Comments on Planning Application 2023/61/93714/E

[2023/61/93714/E](#)

Reserved Matters application (including the consideration of access, appearance, landscaping layout, and scale) for the erection of 10 dwellings pursuant to outline permission 2019/93906 for erection of residential development up to 10 dwellings, and discharge of condition 20 (waste arrangements)

From 2023-93714_ Grouped Plans and Elevations_1022345

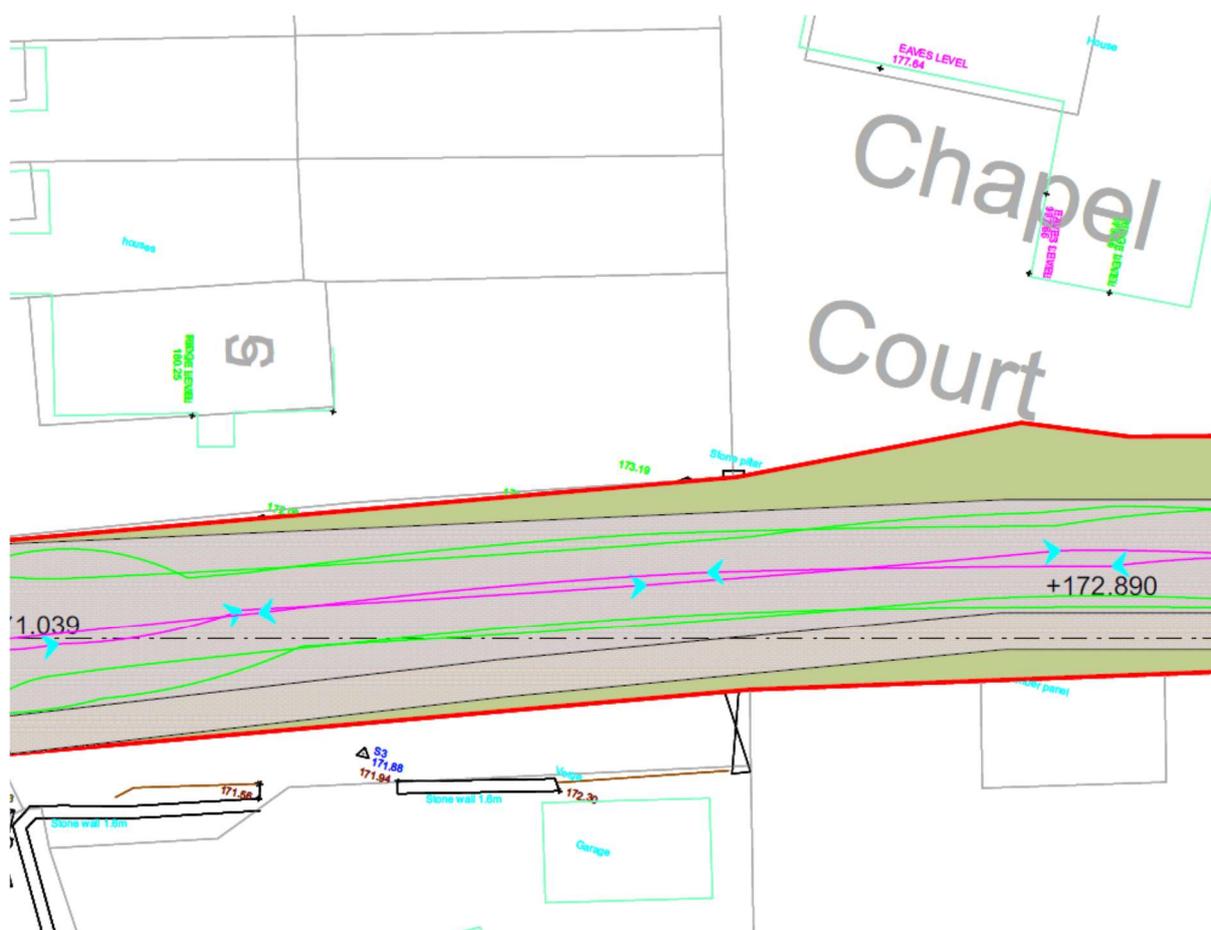
The plans also show the addition of a first floor terrace to House Type 2 including Units 3 and 4, with access from French windows at the rear and by outside stairs at the sides of the properties. It appears that the terrace of the nearest house to Cruck Cottage (Unit 3) would overlook the private garden, the living room windows and the conservatory of this existing property.

Cruck Cottage would also be overlooked by two windows shown on the side elevation of the new house, which would be close to the existing garden fence and facing towards the private garden, the living room windows and the conservatory of the cottage. (A small third window at a lower level is for the downstairs WC.)

From 2023-93714_ Proposed Site Block Layout_1031055

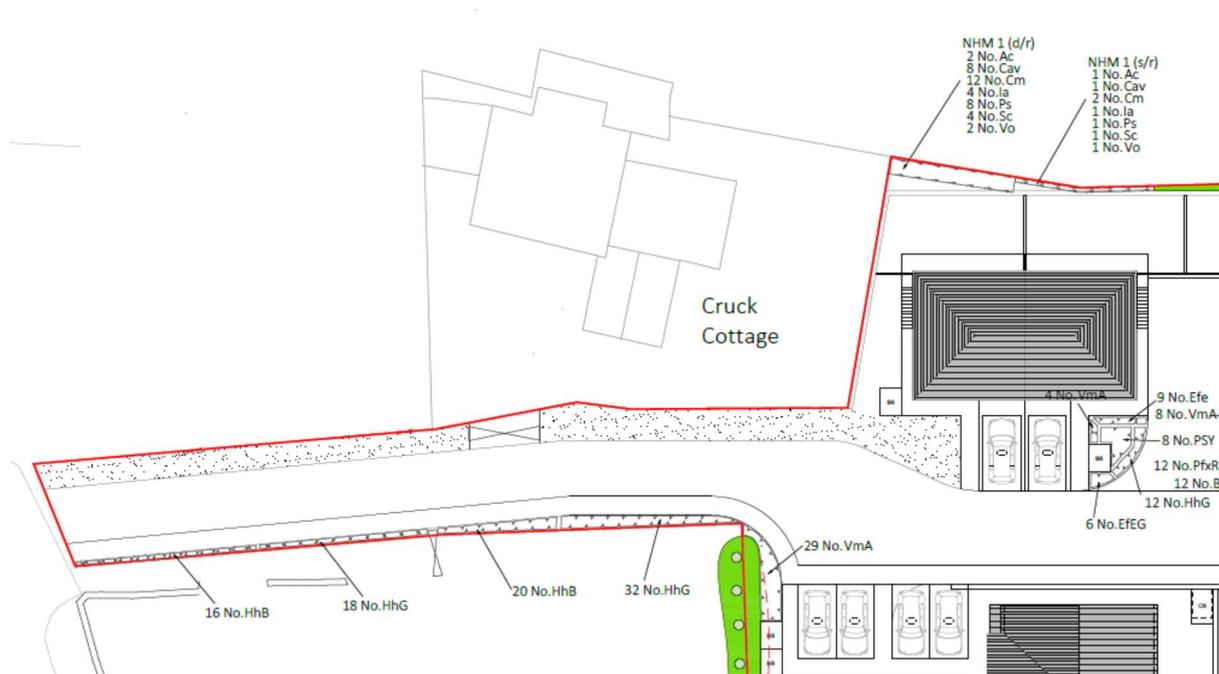
No dimensions have been provided with the latest 2023 plans other than occasional spot heights. 2023-93714_ Proposed Site Block Layout_1031055 shows 600 x 600 mm paving only to the south side of the carriageway, the remainder of which is specified as red permeable resin / brick paviors, with a grass verge on the north side. This replaces a 4.8 m wide carriageway with 1.2 m footpath along the north side and 0.6 m hardstanding on the south side, shown on the 2019 plans.

In order for this planning application to be approved, the revised road detail will need to meet the council's adoptable standard and be duly adopted for public maintenance. If the road is not deemed to meet adoptable standards or until such time that it is adopted, who would be responsible for maintenance of the road and how would this be managed?
